DAVIS-BESSE NUCLEAR POWER STATION, UNIT NO. 1

Amendment No. 42
License No. NPF-3

ATTACHMENT TO LICENSE AMENDMENT NO. 42

SAFETY EVALUATION BY THE OFFICE OF NUCLEAR REACTOR REGULATION
SUPPORTING AMENDMENT NO.42 TO FACILITY OPERATING LICENSE NO. NPF-3

3.1.3.9 The axial power shaping rod group shall be limited in physical insertion as shown on Figures 3.1-5a, -5b, -5c, -5d and 5e.

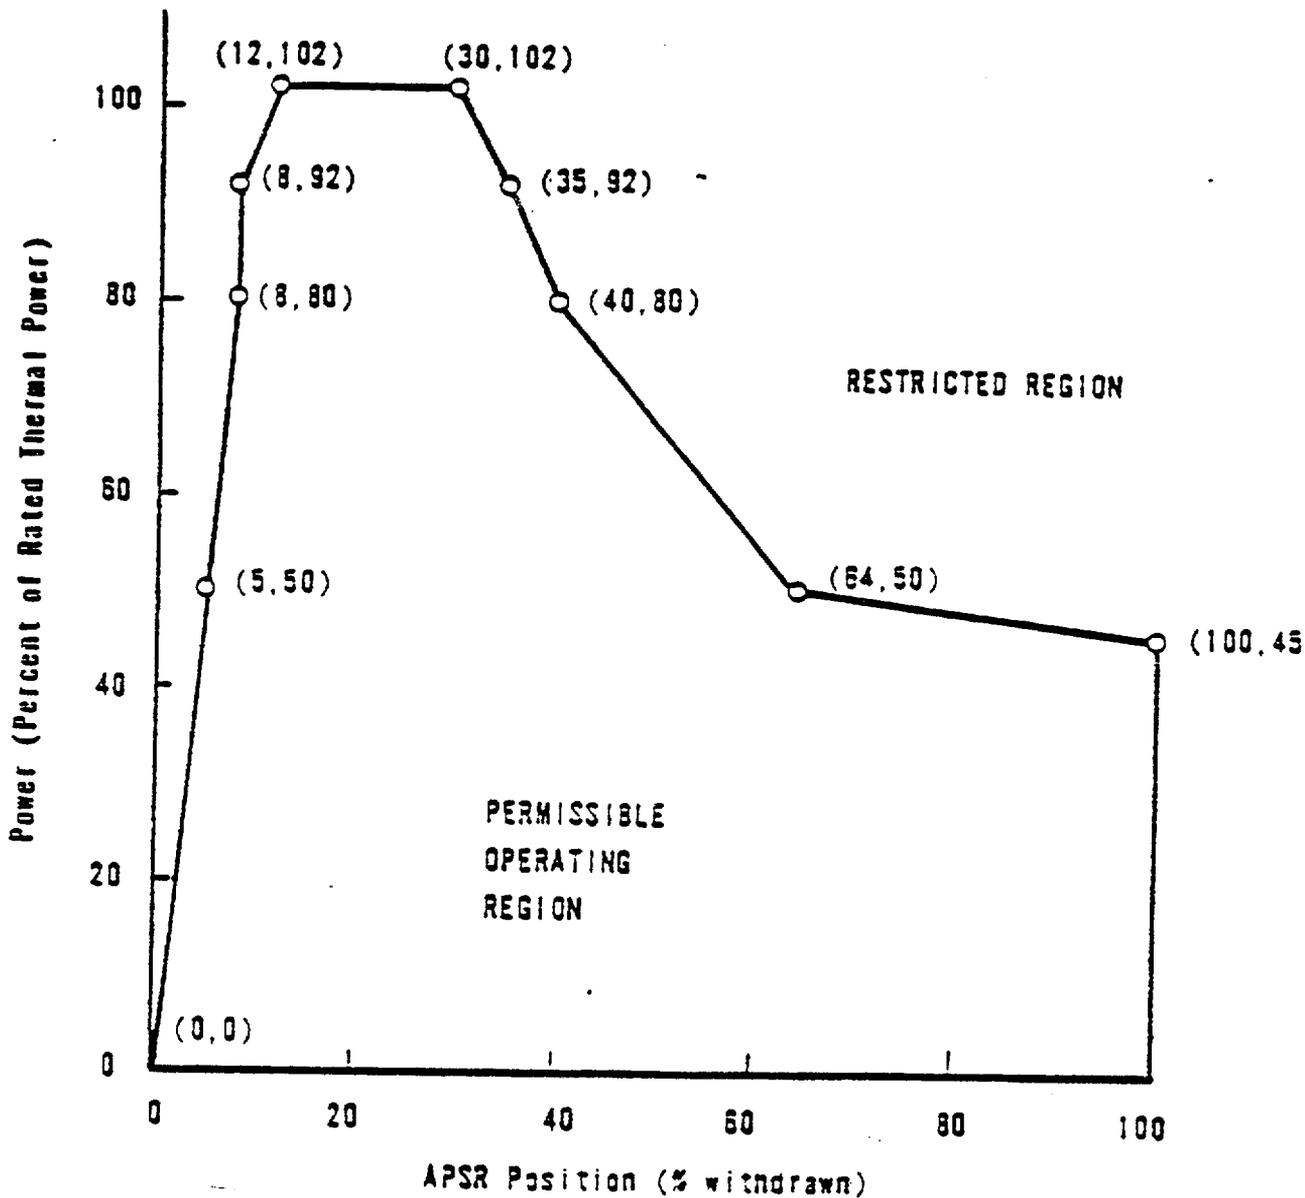
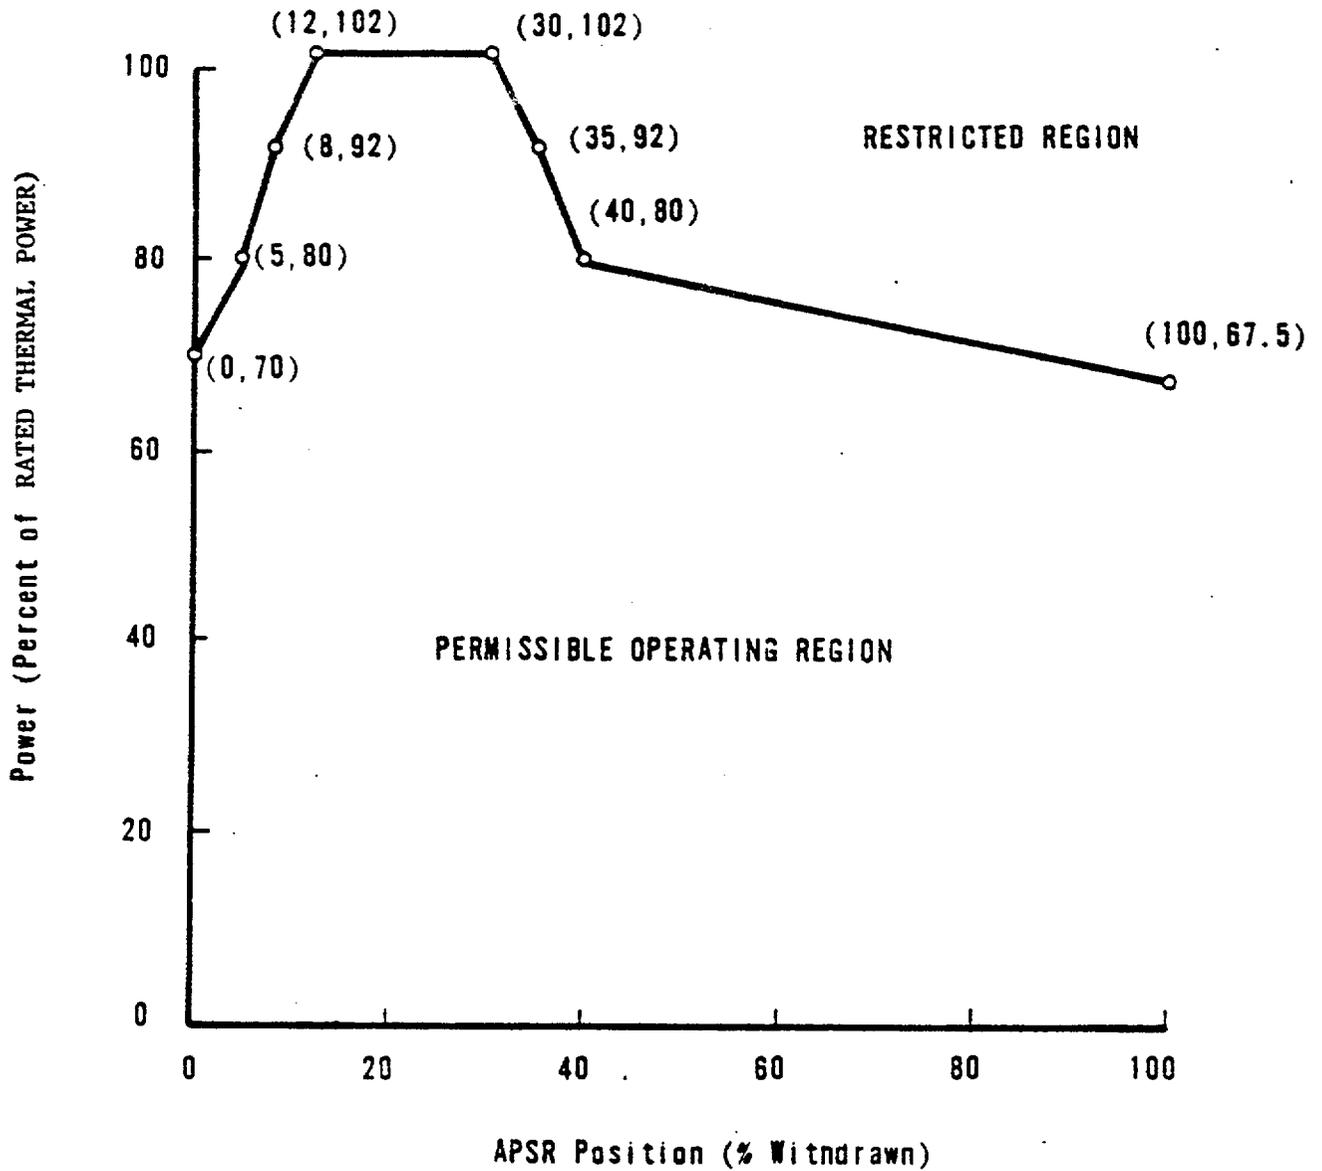
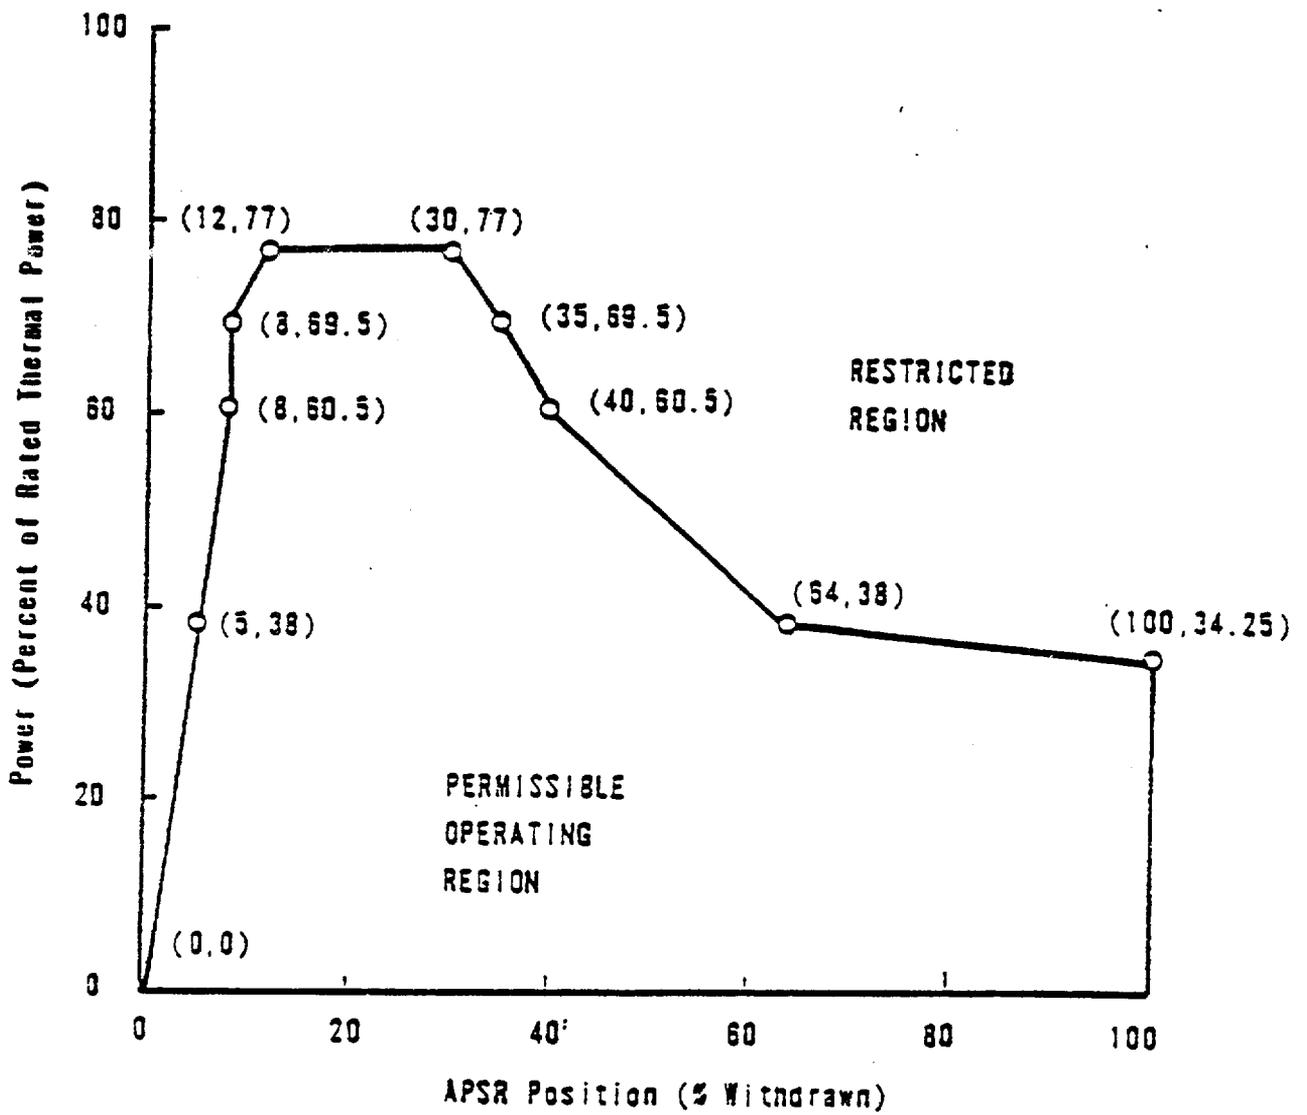
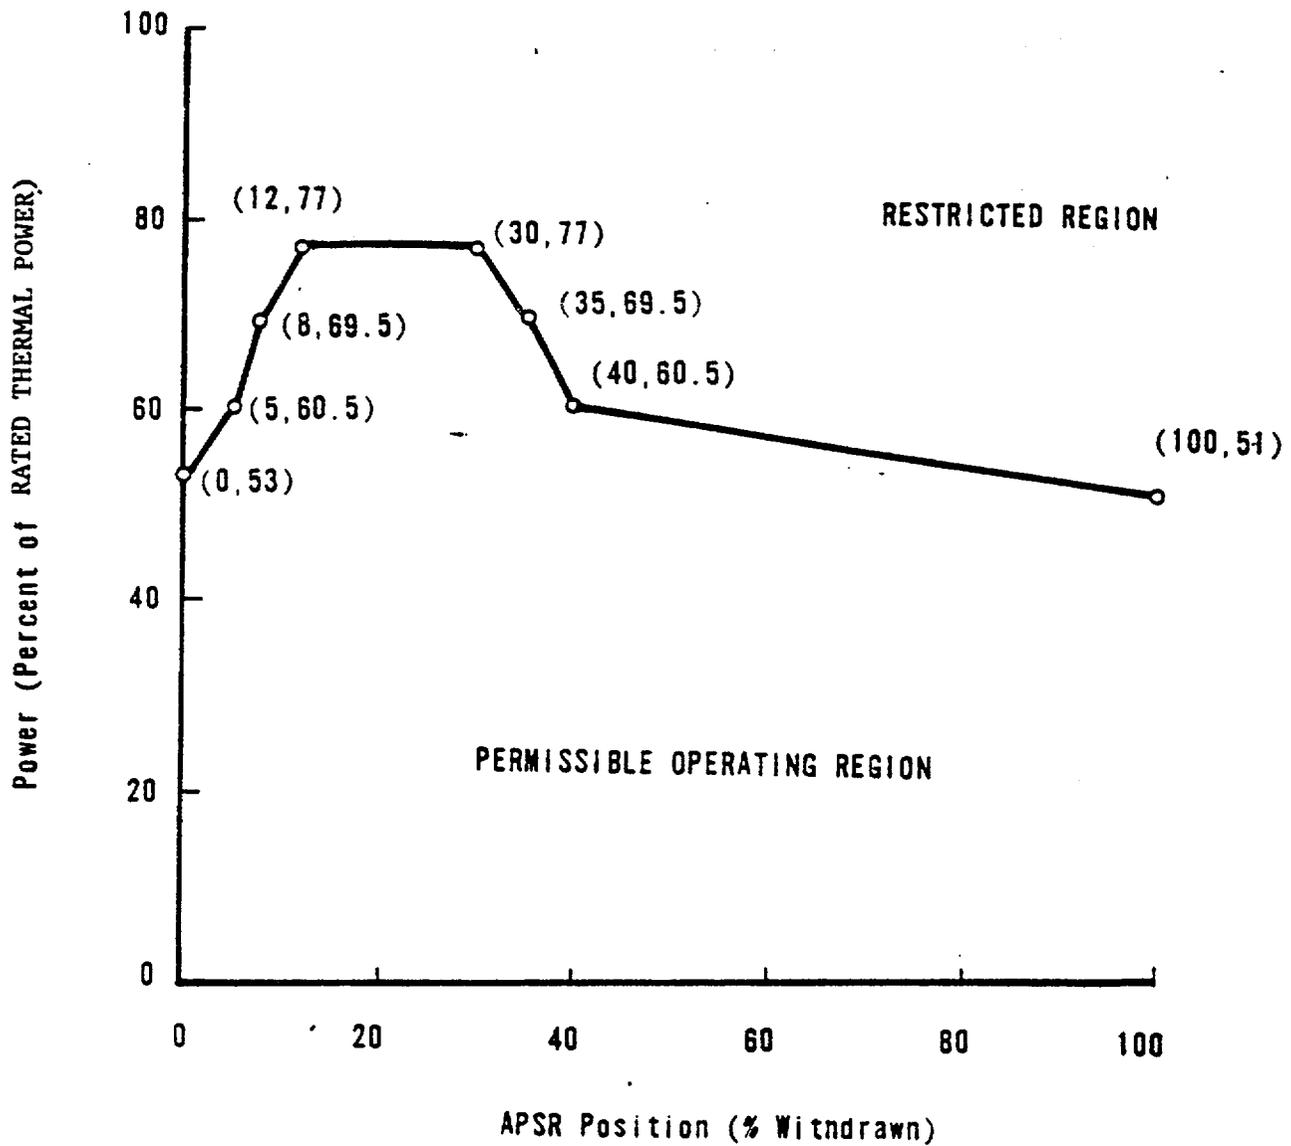
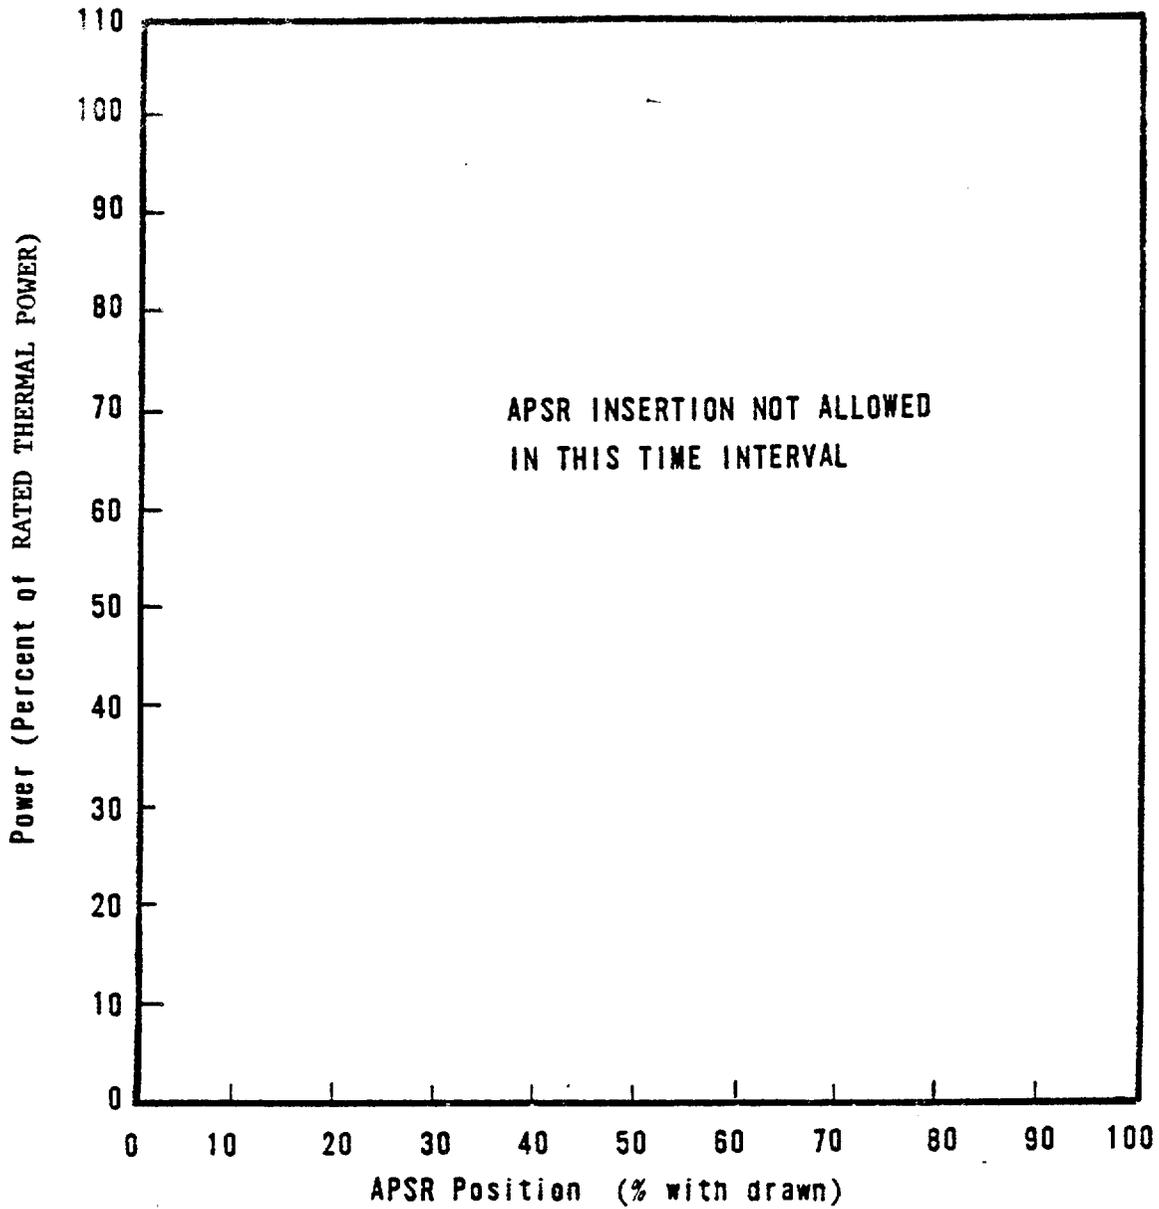
With the axial power shaping rod group outside the above insertion limits, either:

- a. Restore the axial power shaping rod group to within the limits within 2 hours, or
- b. Reduce THERMAL POWER to less than or equal to that fraction of RATED THERMAL POWER which is allowed by the rod group position using the above figures within 2 hours, or
- c. Be in at least HOT STANDBY within 6 hours.

4.1.3.9 The position of the axial power shaping rod group shall be determined to be within the insertion limits at least once every 12 hours except when the axial power shaping rod insertion limit alarm is inoperable, then verify the group to be within the insertion limit at least once every 4 hours.

The present TS Surveillance Requirement, 4.1.3.9, requires that the position of the axial power shaping rod group be determined to be within the insertion limits once every 4 hours. The Station Computer System provides an alarm to the operator whenever the axial power shaping rod group position is not within the acceptable region. The TSs require operation to be brought to within limits within 2 hours or be brought to hot-standby within 6 hours. However, with the Station Computer System alarm operating the operator is immediately alerted to the out-of-limit status of the axial power shaping rod group position and corrective action can be initiated. The proposed modification to the TSs would reduce the Surveillance Requirement to at least once every 12 hours instead of every 4 hours.

If the Station Computer System alarm is inoperative, the Surveillance Requirement would remain at least once every 4 hours. The proposed change would relieve the operator of excessive surveillance and would make the axial power shaping rod group position Surveillance Requirement identical to that for the regulating rod group position. We find this proposed TS modification acceptable.
